Appeal of Development Permit DP073108

65 Carlton Drive, Campbell Industrial Park

We are formally appealing the approval of Development Permit DP073108

EXISTING REAL-WORLD DATA

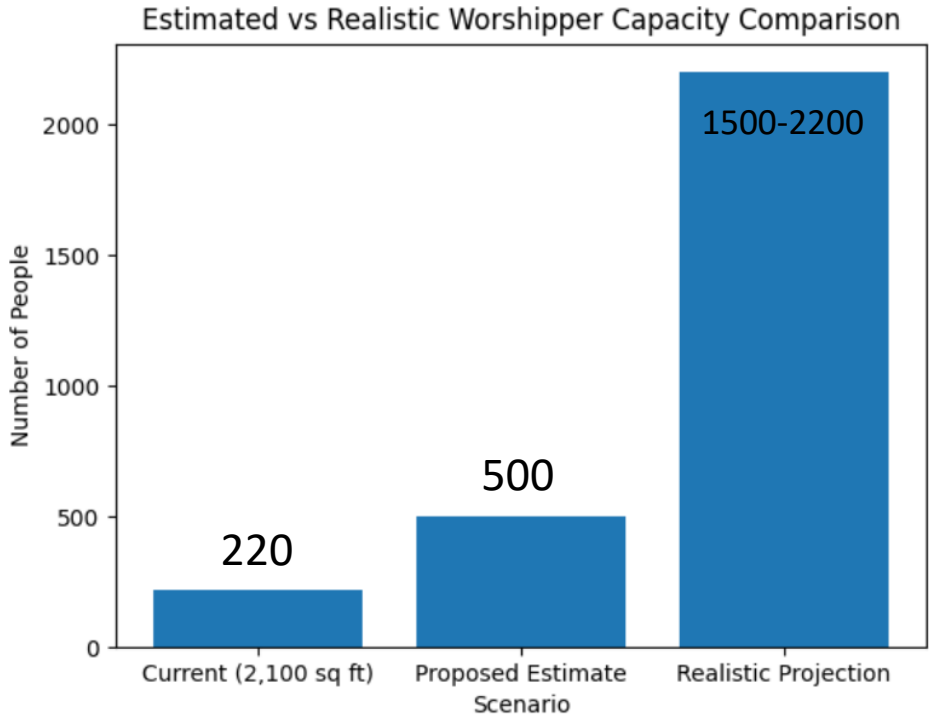
- Current mosque size: **~2,100 sq ft**
- Generated: **Approx. 158 additional parked vehicles**
- Observed: **1.4 persons per vehicle resulting in approx. 220 people in attendance**

Observed vs Projected Impact

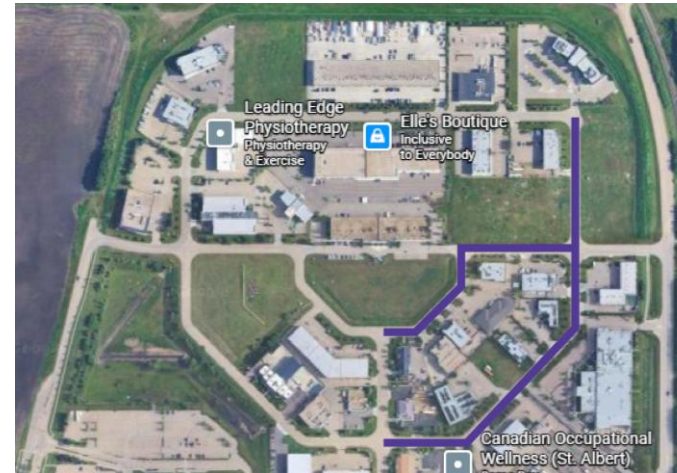
The existing 2,100 sq ft space is already generating approx. 158 vehicles extra vehicles estimating at 1.4 persons per vehicle results in approx. 220 people.

The proposed 22,000 sq ft development is projected at only 500 persons—but based on real-world use, and comparison to the current location sqft we can anticipate upwards of 10x – approx. 2,200 people.

Therefore 500 people appears to be significantly underestimated.(Approx 232 vehicles)
